# ***FINAL ENVIRONMENTAL IMPACT REPORT***

## ***Villa Marina Mixed Use Project***

***ENV-2004-3812-EIR***

**RECOMMENDATION FOR EIR CERTIFICATION**

Revised Figure 2  
Aerial View of Project Site  
and Surrounding Uses

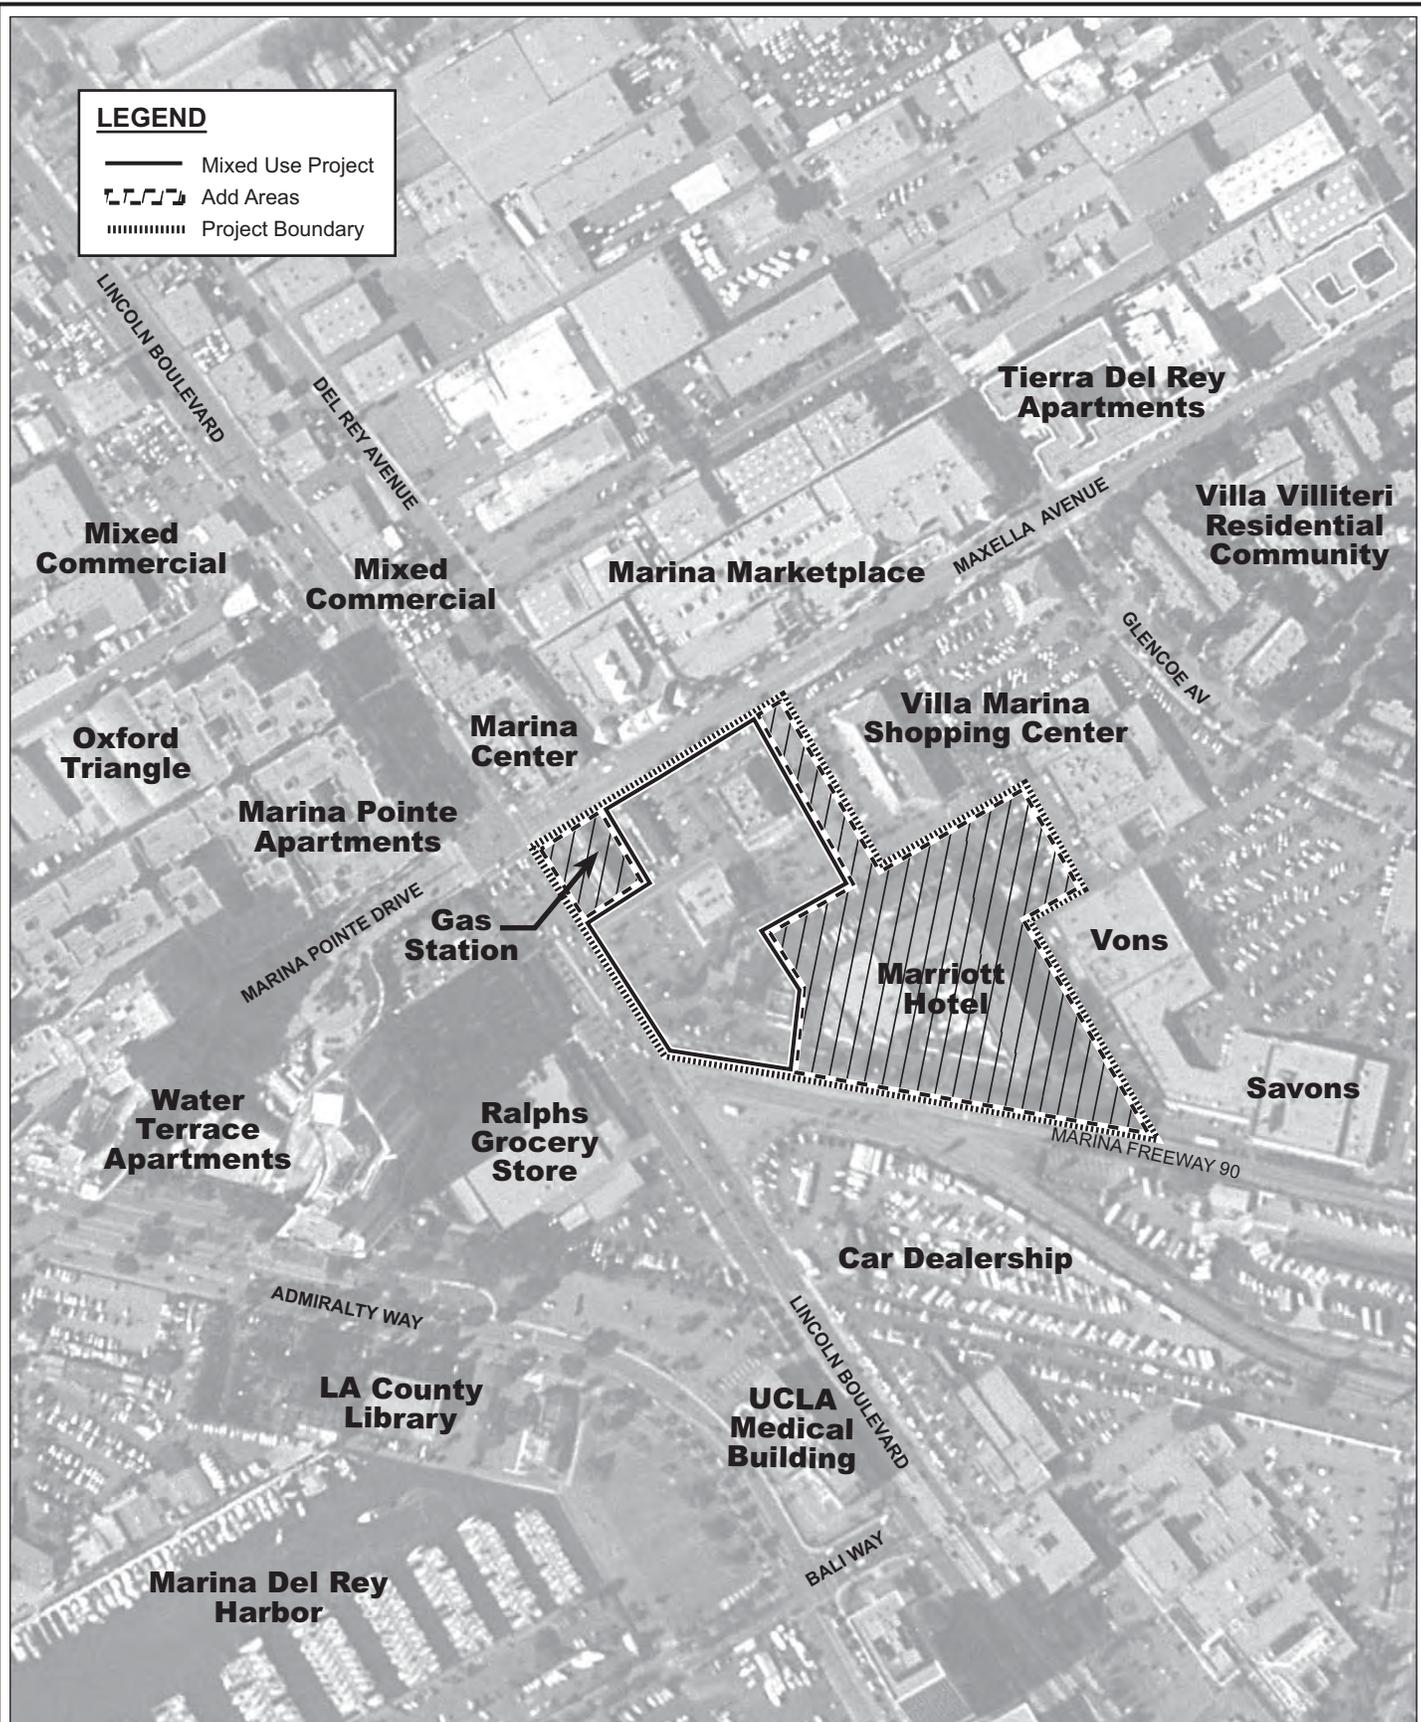
*Figure 2. Aerial View of Project Site and Surrounding Uses (Page 38)*

III.B.1 Section II.B, Figure 2, Aerial View of the Project Site and Surrounding Uses, page 38; replace with the figure presented on page 55.

Figure 2 on page 38 of the Draft EIR has been revised per the comment. Please refer to Correction and Addition No. III.B.1.

Revised Figure 10  
Surrounding Land Uses

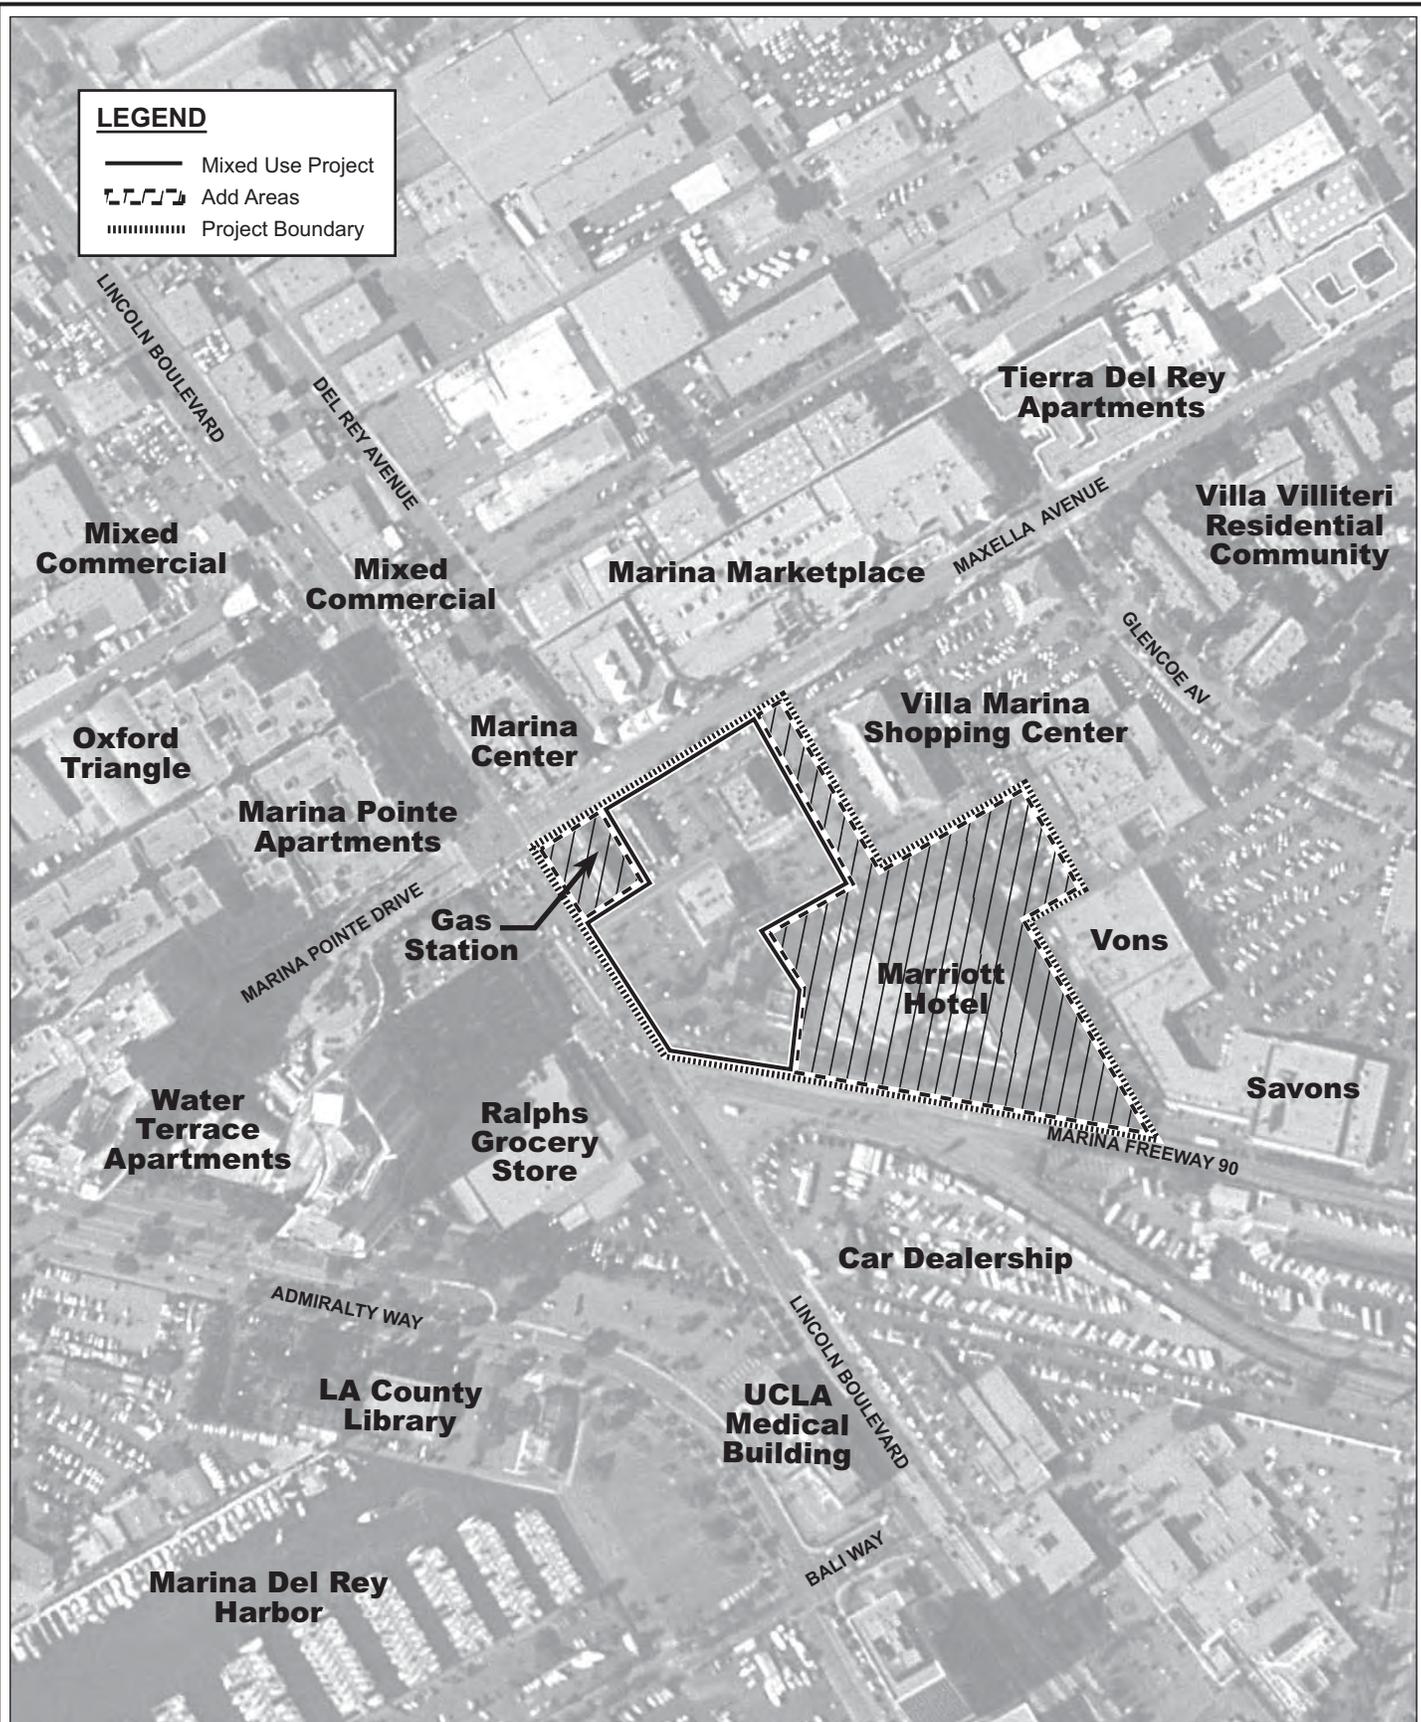
*Figure 10 Surrounding Land Uses (Page 61)*

IV.A.1 Section IV.A.2.a.(3), Figure 10, Surrounding Land Uses, page 61; replace with the figure presented on page 56.

Figure 10 on page 61 of the Draft EIR has been revised per the comment. Please refer to Correction and Addition No. IV.A.1.

Revised Figure 21  
Noise Sensitive Receptors  
and Measurement Locations

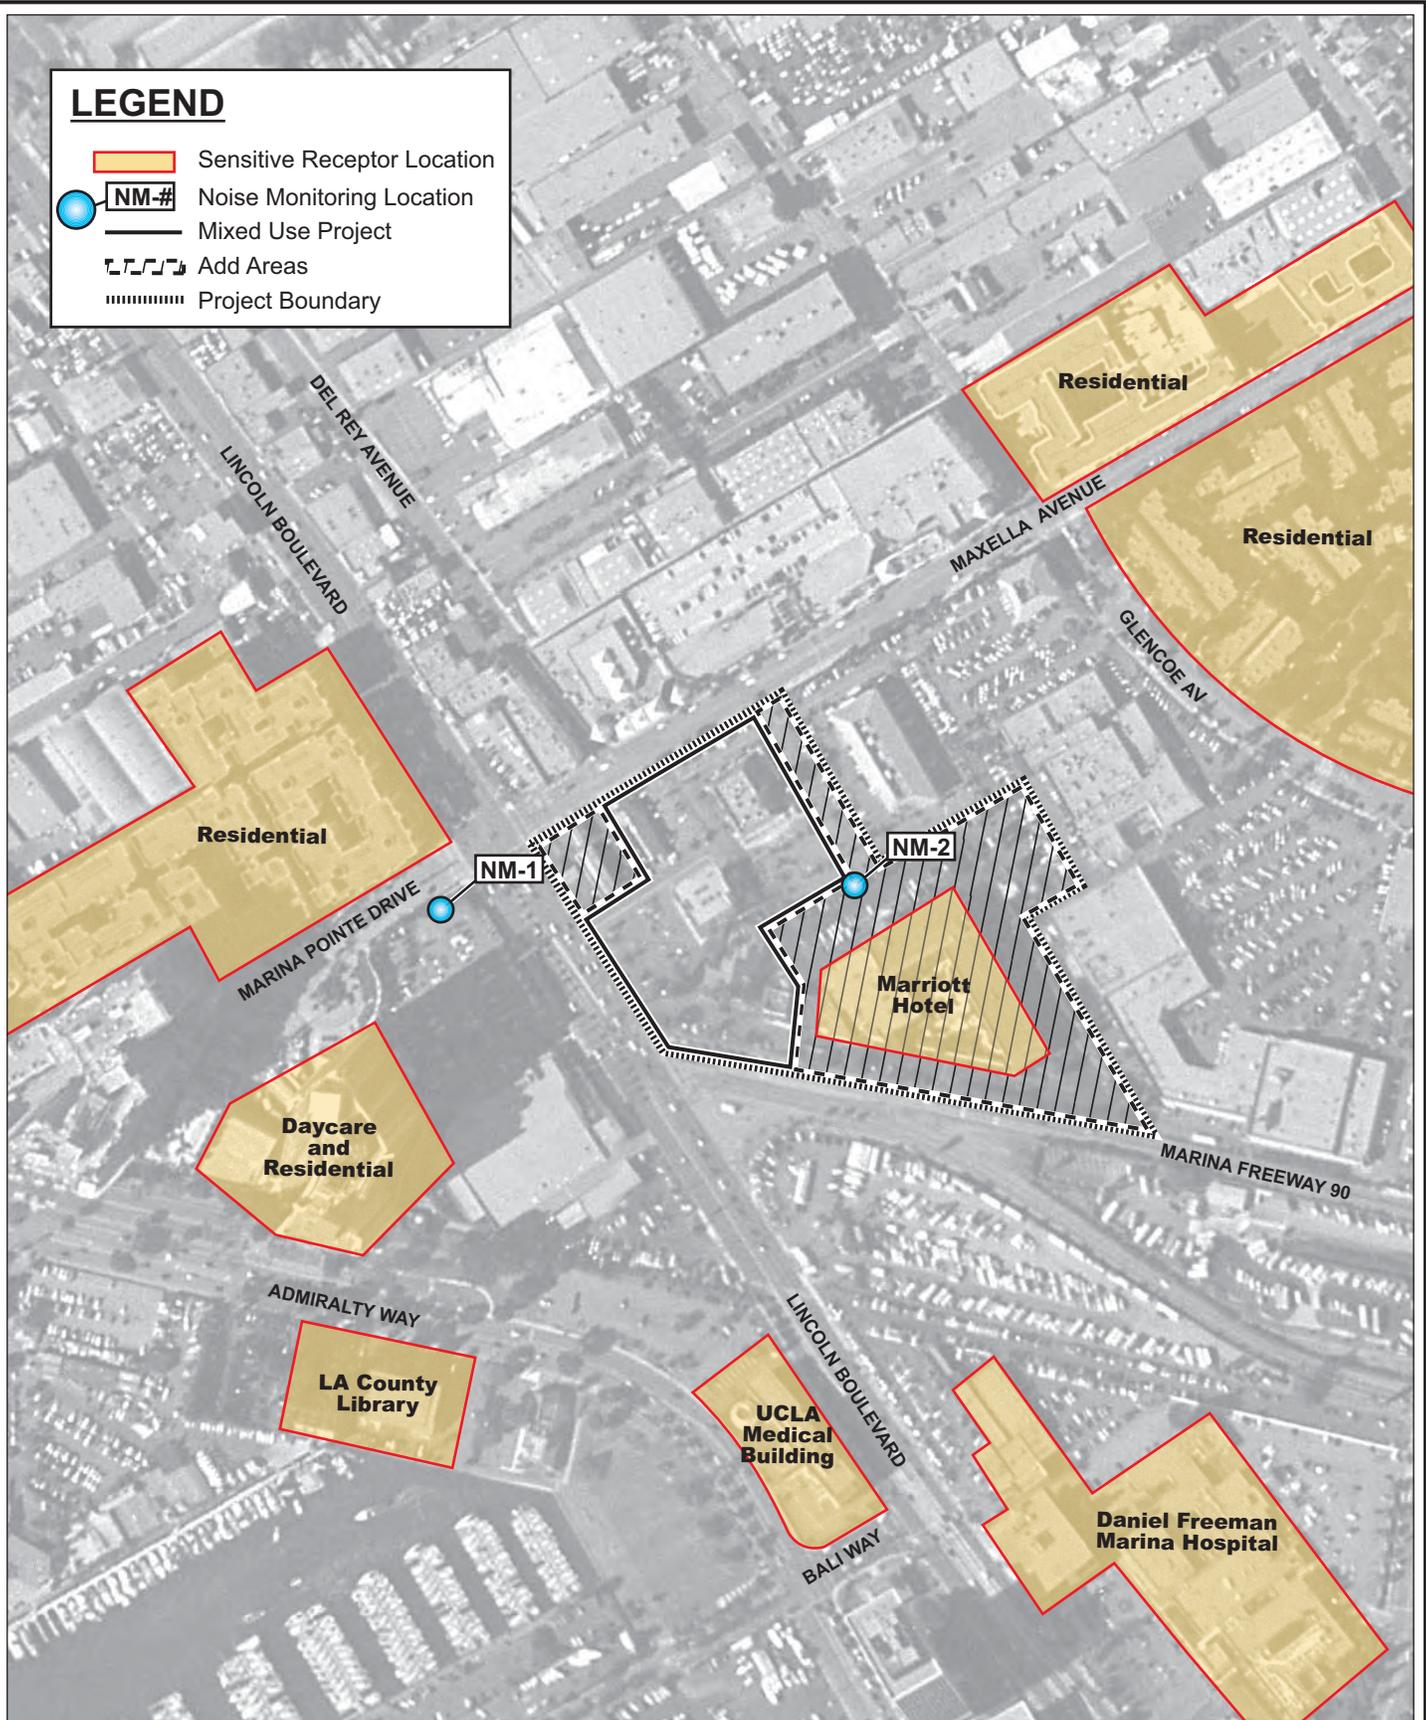
*Figure 21 Noise Sensitive Receptors and Measurement Locations (Page 174)*

The City of Los Angeles' Noise Thresholds Guide states that, "residences, schools, motels and hotels, libraries, religious institutions, nursing homes and parks are generally more sensitive to noise than commercial and industrial uses." There are three such facilities within the general vicinity of the proposed project that are clearly visible in Figure 21, but are not analyzed:

**IV.E.1** Section IV.E.1.c(1), Figure 21, Noise Sensitive Receptors and Measurement Locations, page 174; replace with the figure presented on page 59.

Noise impacts were analyzed in Section IV.E of the Draft EIR for various sensitive receiver locations, including the receiver locations that are located closest to the Mixed Use Project Site. With the exception of the Marriot Hotel property (which is part of the Project Site), no significant noise impacts would occur during the short-term construction or long-term operation periods. While other noise-sensitive uses may be visible on Figure 21 on page 174 of the Draft EIR (Noise Sensitive Receptors and Measurement Locations), no noise-sensitive uses are located closer than 400 feet from the Mixed Use Project Site. Of the three (3) additional noise-sensitive uses pointed out by the Commentor, the Kid's Pointe Day Care, which is located immediately adjacent to the Regatta residential development that was identified in the Draft EIR as a noise-sensitive use, is closest to the Mixed Use Project Site at approximately 600 feet. As such, noise during construction at the Kid's Pointe Day Care would be similar to the impacts at the Regatta residential development (i.e., 3.6 dBA [L<sub>eq</sub>] increase in ambient noise level). Thus, noise level increases would not exceed the 5-dBA significance threshold at this location, and as such, impacts would be less than significant. Also similar to the Regatta residential development, noise level increases attributable to the Revised Mixed Use Project at the Kid's Pointe Day Care would be less than significant. At noise-sensitive locations located farther away than the Regatta residential development and Kid's Pointe Day Care (e.g., the Los Angeles County Library and UCLA Medical Building), construction- and operations-period impacts would also be less than significant.

Figure 21 on page 174 of the Draft EIR has been updated to identify the locations of the Kid's Pointe Day Care Los Angeles County Library and UCLA Medical Building. Please refer to Correction and Addition No. IV.E.1.
